Planning Commission Meeting

April 11, 2023 6:00 PM

4.I. 3558-3668 Elm St., 522-530 Porsche Ave., 543-573 College St., 3560-3572 Perkins St., 0 Perkins St. Revised Site Plan Review

DATE: April 4, 2023
TO: Adrienne Senter
FROM: Lynn Patterson
RE: **Site Plan Review – 3558 Elm Street Revised Plan**

TCRP 2.0

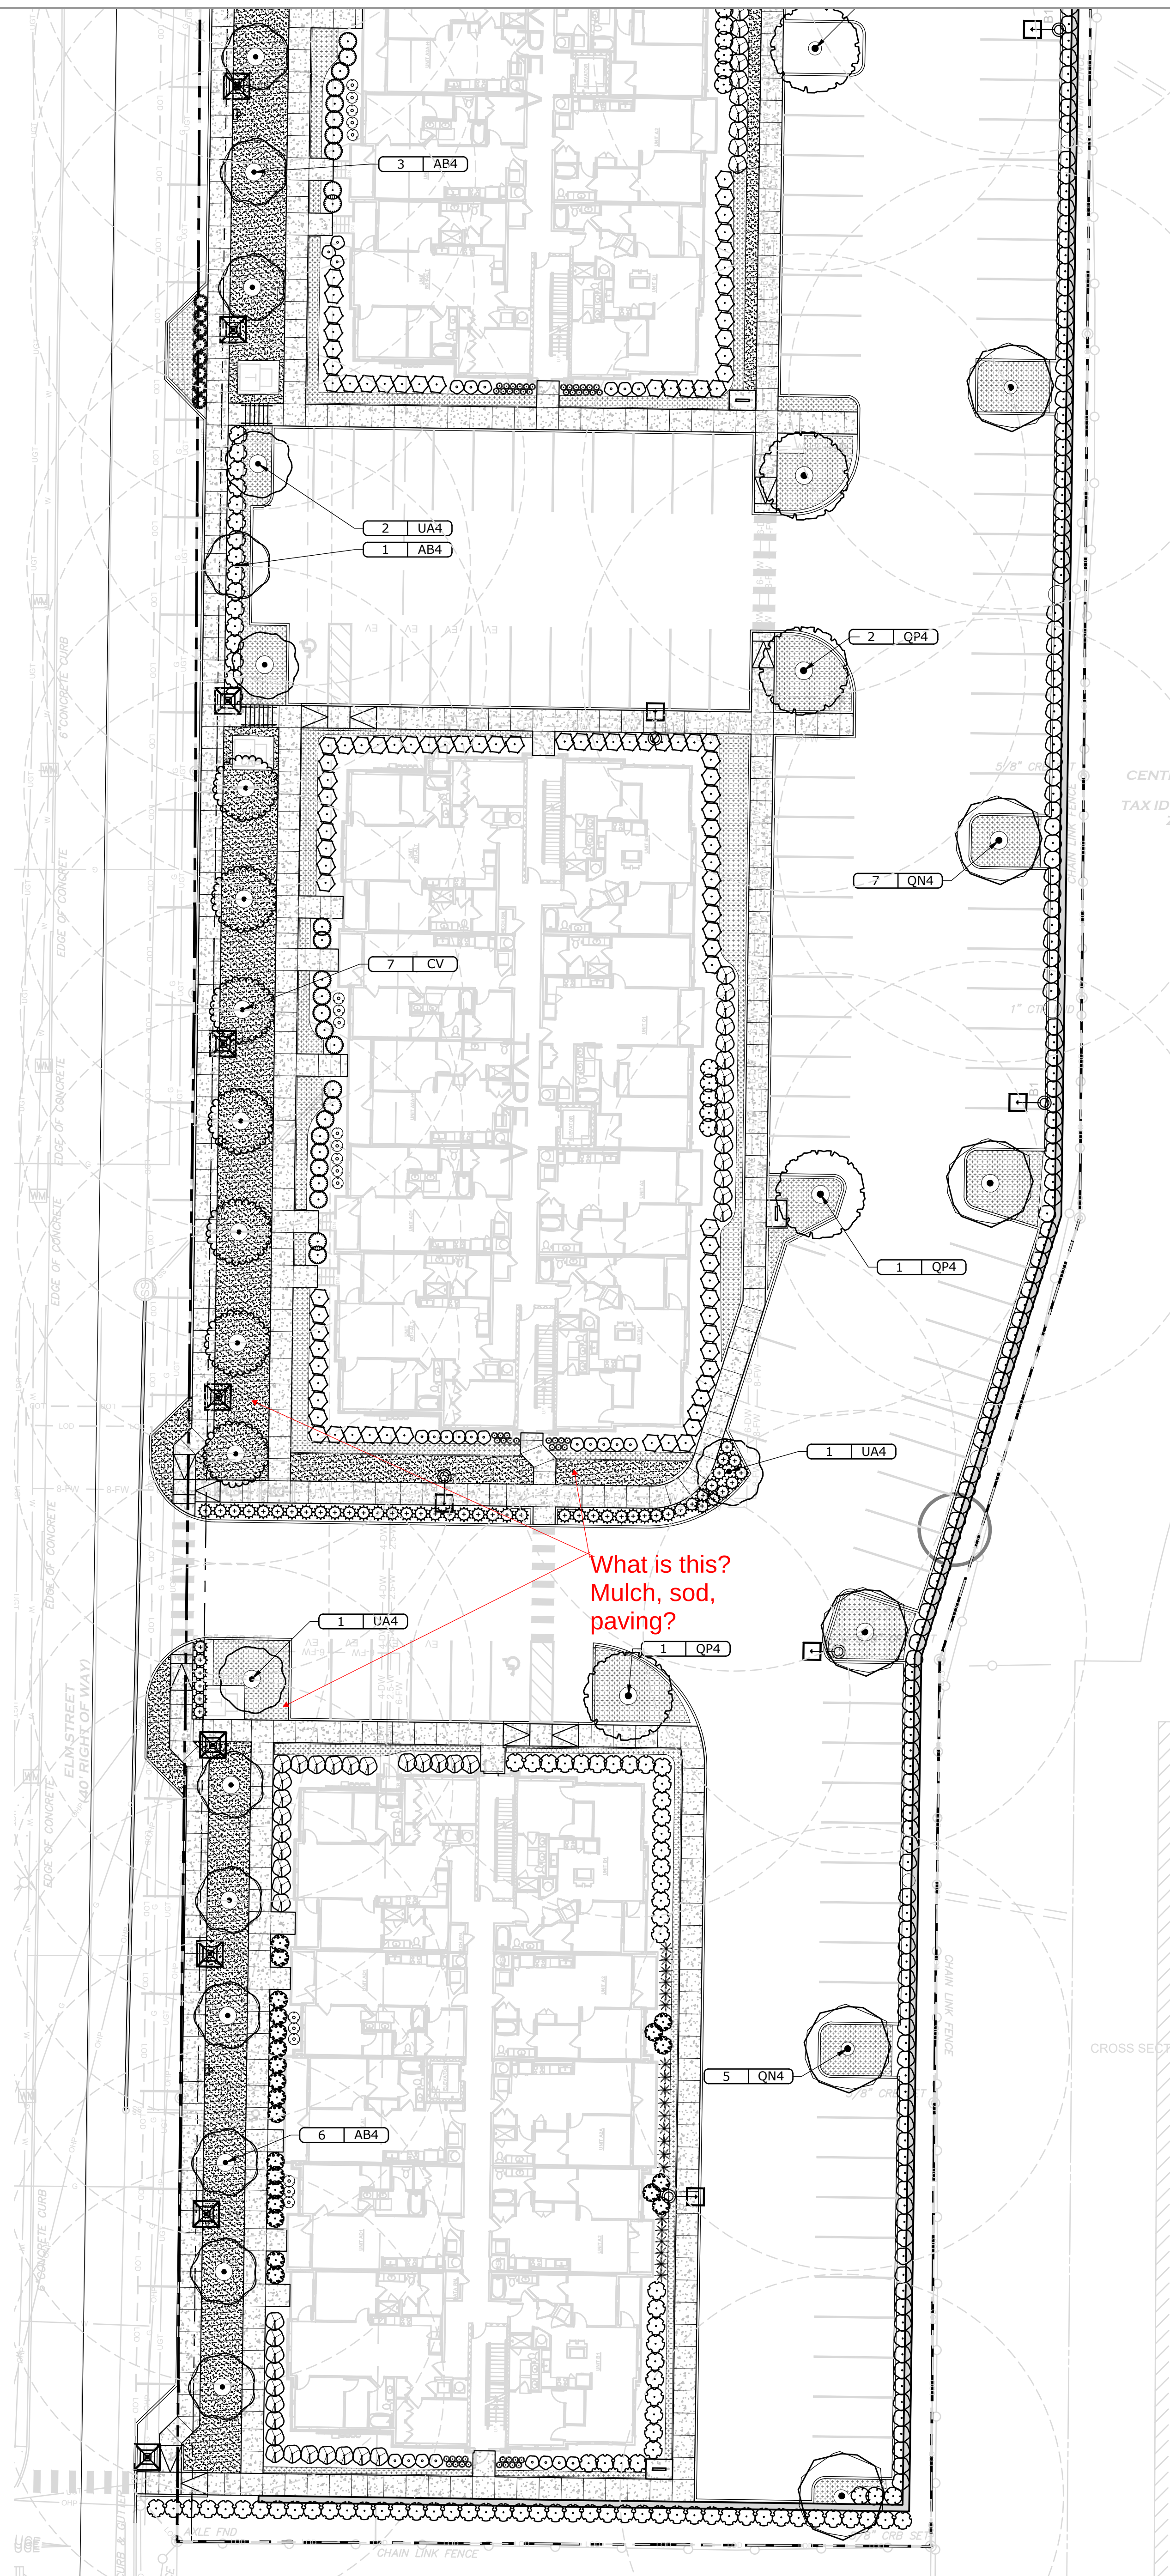
Same comments as on last sheet.
